NHTSA Recall:	26V-174	Product:	Lineage Power Entry Steps
TC Recall:	2026-164	Repair Time:	0.5h

This document outlines the procedure to reinstall the power entry step switch on affected Lineage motorhome units. The original configuration installs the plunger switch in the door and the magnetic sensor on the hinge; this repair discards the magnetic sensor and relocates the plunger so that the plunger is installed on the hinge and the contact plate is installed in the door.

Fig. 2 — Magnetic sensor (hinge side) and plunger switch (door side) removed to expose wiring.

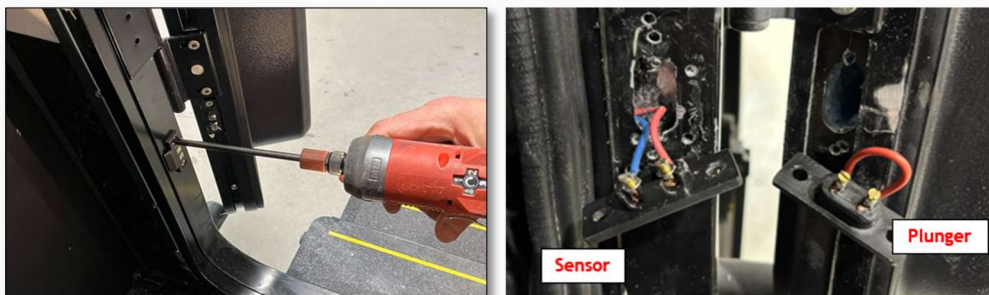
Step 1 — Remove the mounting screws from both the magnetic sensor and the plunger switch, and pull each unit out far enough to access its wiring.

Fig. 3 — Clearance cavity drilled in door frame for plunger terminals.

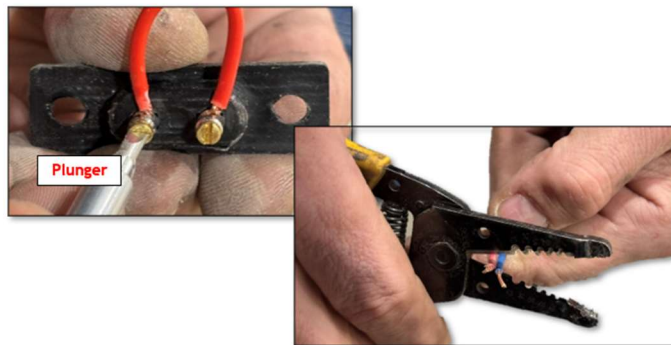
Step 3 — Drill a clearance cavity in the door frame to accommodate the plunger switch terminals.

***Note:** Take special care not to drill deep — only about ¼" of clearance is needed for the terminals.*

Fig. 4 — Plunger switch relocated from door to hinge, wired and seated.

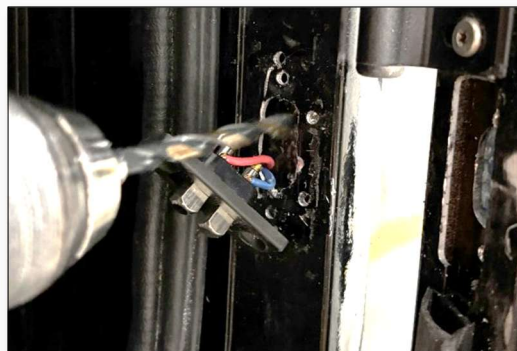
Step 4 — Attach the wires from the hinge-side harness to the plunger switch terminals. Insert all threads fully and tighten properly.

Fig. 5 — Contact plate installed in door panel; plunger visible on hinge side.

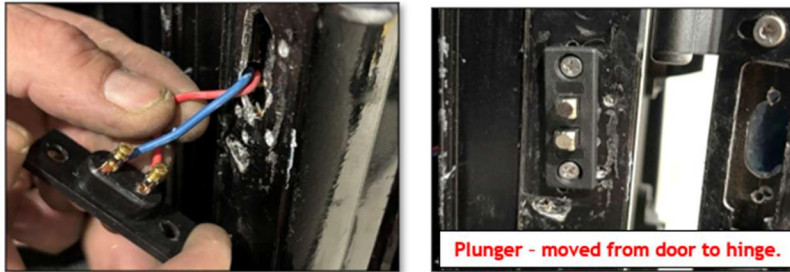
Step 5 — Install the new contact plate (PN 421713) in the door panel over the original plunger installation location, using the two #6 screws.

***Note:** Note the counter-sunk side of the contact plate holes so the screws tighten flush.*

***Note:** Screw specification: #6 12 x 3/4 Oval #2 Quad Head Full Deep Thread T/17 Nickel.*
